**Groundwater Model Report Addendum
Red Hill Bulk Fuel Storage Facility
JBPHH, Oahu, Hawaii**

March 17, 2025

Prepared for NAVFAC Hawaii by
AECOM Technical Services Inc
1001 Bishop Street Suite 1600
Honolulu HI 96813-3698

Chart 3-1: Reported Average Water Budget (top) and Corrected Average Water Budget (bottom) from Regional GWFM

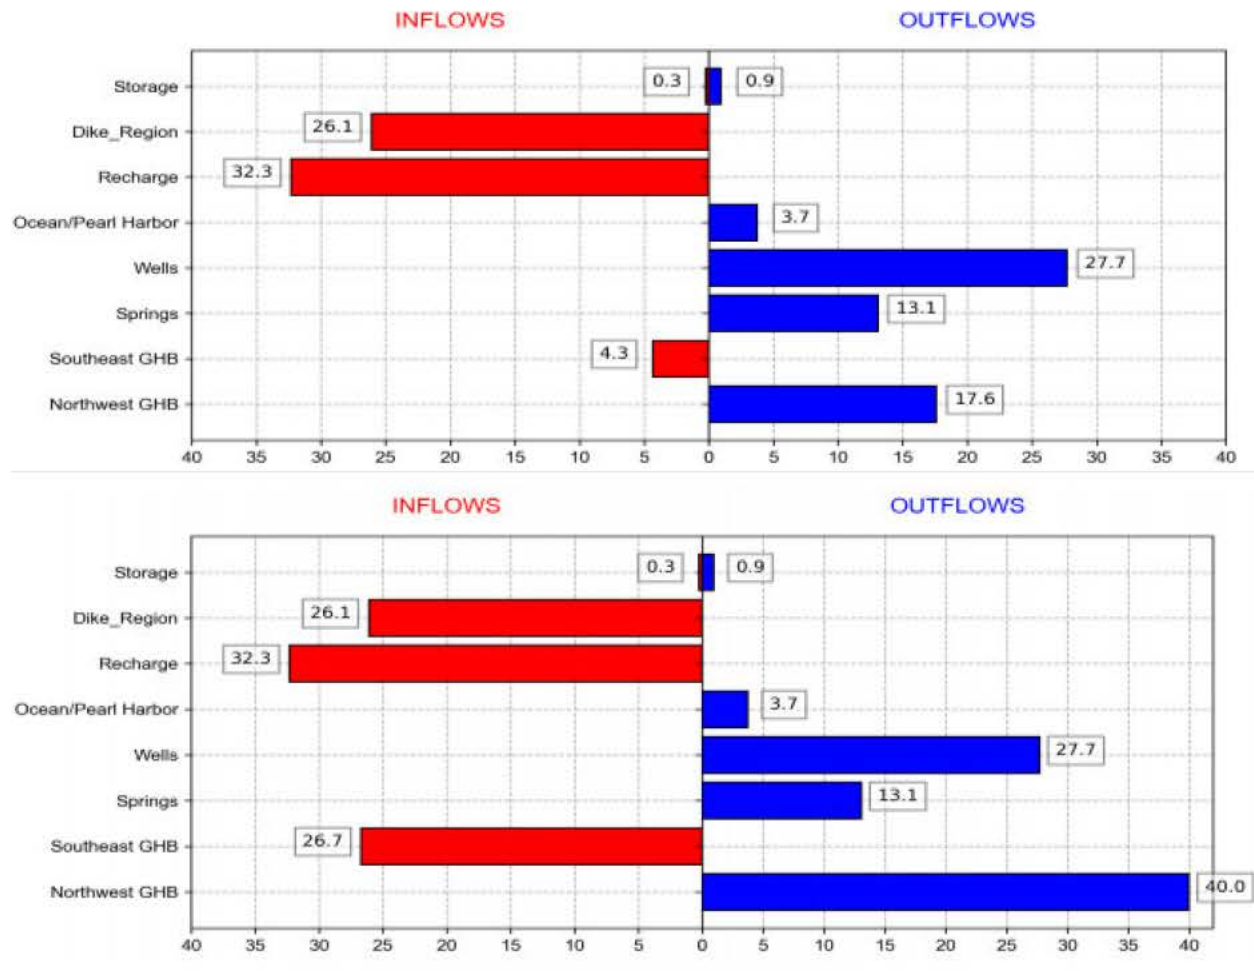
Calculation of the model water budget both in the calibration process and in subsequent reporting was affected by the misassignment of the GHB reach at node 188,806, causing the outflow from the node to be subtracted from the inflow to the southeast GHB. The result was a reported inflow from the southeast GHB of 4.3 mgd when the correct inflow was 26.7 mgd. Outflow from the northwest GHB then also increased by the same 22.4 mgd. Overall flow through the model increases from approximately 73 mgd to 95 mgd, an approximately 30% increase in total water flux (Chart 3-1).

Although the impacts of this issue on the model simulation results are limited to the reported water budget, the incorrect inflows were used during the model calibration process with PEST. Impacts to the model calibration were tested by re-running regional model calibration with the corrected GHB node. Head calibration statistics are presented in Table 3-1 and Table 3-2 for the reported and recalibrated models, respectively. A comparison of the calibrated parameters is shown in Table 3-3. Calibration statistics, while not identical, are generally very similar. Root mean square error (RMSE) of basal aquifer wells varies between the two models by 0.00 to 0.03 ft, i.e., a negligible amount. Calibrated parameters are also similar, with the largest changes related to the basalt weathering parameters. The weathering depth was increased from 736 to 1,126 ft, but the weathering reduction factor below streams was reduced from 6,624 to 2,236.

Chart 3-2: Average Water Budget for Recalibrated Model

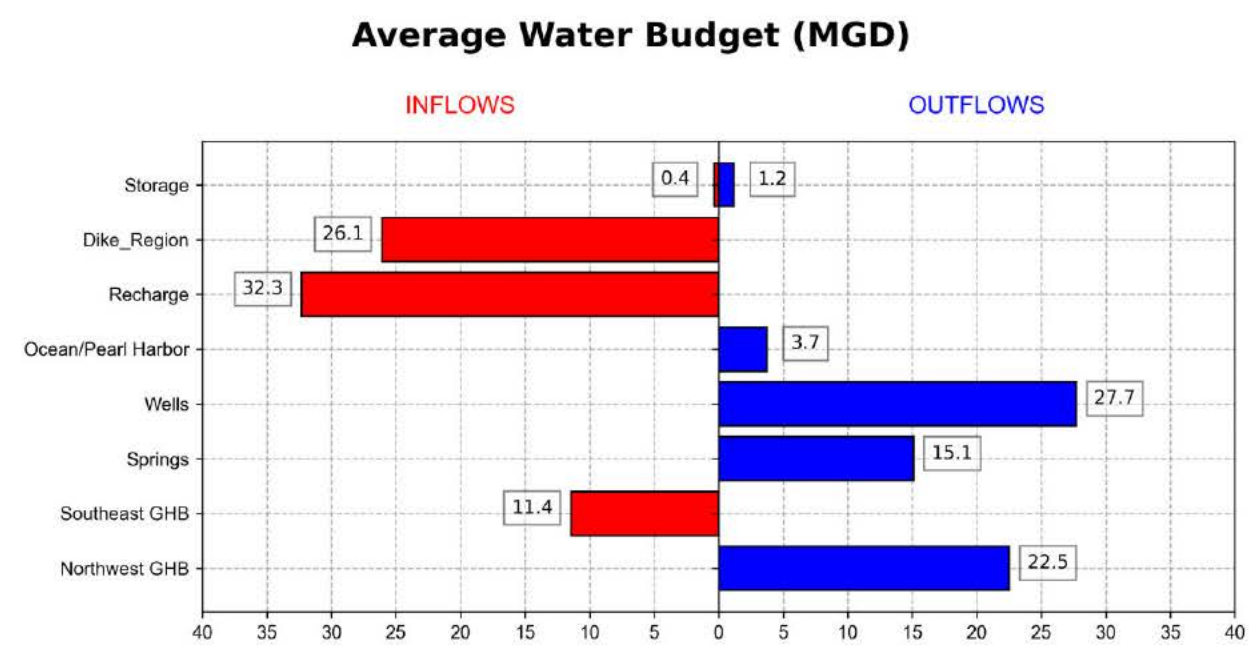
Impacts were primarily noted in the water budget where southeast boundary inflows were reduced from 26.7 mgd to 11.4 mgd but were still larger than the target of 2.0–4.9 mgd. A summary of the average water budget across all stress periods is presented on Chart 3-2. The final 11.4 mgd inflow from the southeast GHB from the recalibrated model is comparable to previous model versions where the GHB misassignment issue was not present. These results indicate that the GHB misassignment issue was only partially responsible for southeast GHB inflows exceeding conceptual estimates, while other conceptual or structural discrepancies account for the remainder of the difference. The flux targets and water budget estimates, with the exception of spring flow rates, are conceptual and not values that can be directly measured. The values obtained from those estimates are intended to provide general guidance to the overall model water budget and are not considered fixed accurate targets. It is possible that conceptual estimates are oversimplified and not as accurate at the calibrated model values.

The problem has been resolved by correctly assigning node 188,806 to GHB reach 1, which rectifies issues pertaining to both model calibration and reporting of results.

The difference between the estimated and simulated southeast boundary inflow is lessened but not completely eliminated by the resultant reduction of the inflow from (b) (3) (A), compared to the conceptual estimate of (b) (3) (A). Note that this difference between the model setup and conceptual estimates is not an error because the conceptual estimates are not field-measured values that must be matched, but instead represent reasonable bounds on the calibration of the water budget. Some additional flexibility in the water budget may be considered in future model versions, such as allowing increased inflows to be distributed between both the southeast GHB and the dike region boundary, which is currently set as a specified flux and was not subject to calibration. Inflows from these boundaries are estimated based on USGS recharge calculations (Engott et al. 2017). These recharge estimates in the dike region, where the majority of the water originates, predict recharge to be between 30% and 50% of rainfall. It is unlikely that the percentage of rainfall that enters the water table as recharge is significantly greater than this, but variations in the range of 10%–20% are reasonable. Further consideration will be given to both the conceptual water budget as well as the methods used to match the estimates in the model calibration process.

Figure 2-1: Excerpt from EPA Comments on Flux Targets

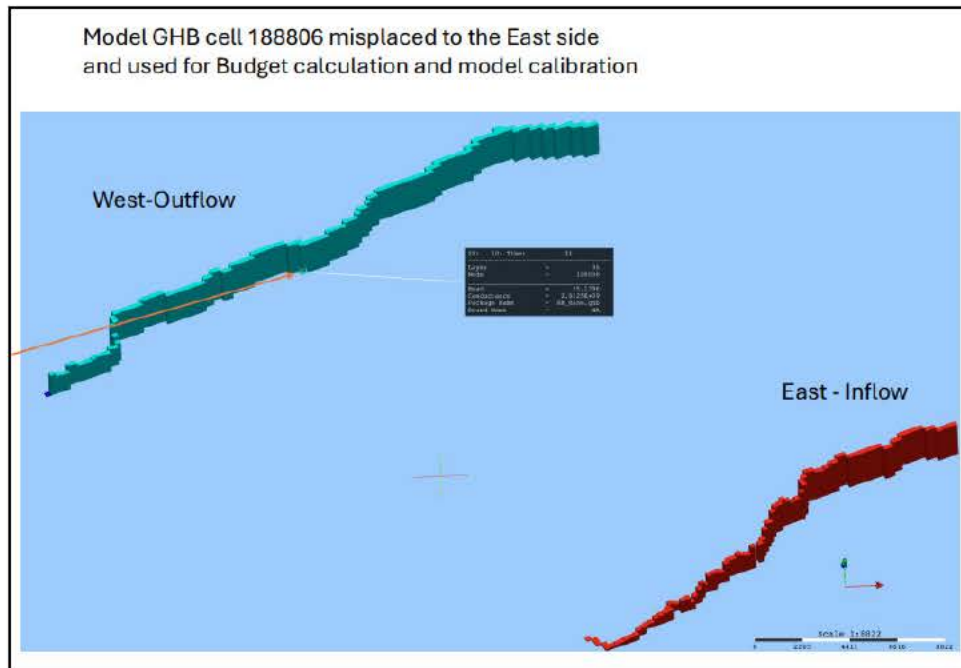
The October 9, 2024 email from EPA to the Navy included comments pertaining to the inclusion of flux targets into the model calibration process with the PEST software suite (Watermark Numerical Computing, 2023). The regional groundwater flow model (GWFM) calibration used estimates from the conceptual water budget to develop flux targets for inflows from the southeast boundary and outflows to Kalauao Springs. Each of the 44 stress periods was assigned a target flux at the last time step for each of the two boundary condition reaches. The comments noted that in the PEST run record file (.rec), outputs were recorded for only 7 of the 44 targets for each boundary reach, and that some were extracted to the incorrect times, as shown on Figure 2-1.

The root cause of the issue is an incompatibility between custom output control in the MODFLOW code and “targetpestu,” the utility included with the Groundwater Vistas (Rumbaugh & Rumbaugh, 2020) graphical user interface (GUI), which extracts simulated values at target locations corresponding to observed values from binary model output files. Custom output control was used to reduce file sizes and model run times by writing the cell-by-cell flow binary file (.cbb) only at the last time step of each stress period. Records from the PEST run indicate that targetpestu may have required all time steps to be written out to the .cbb file, resulting in missing or mismatched simulated values.

In future model versions, this issue will be corrected by writing out the cell-by-cell flows for each time step. It has been confirmed that this corrects the calculations for simulated flux values extracted by the targpestu routine. Additional work may also be conducted to identify a solution that would allow for the use of custom output control with targpestu, thereby reducing the size of the .cbb files and maintaining reduced run times.
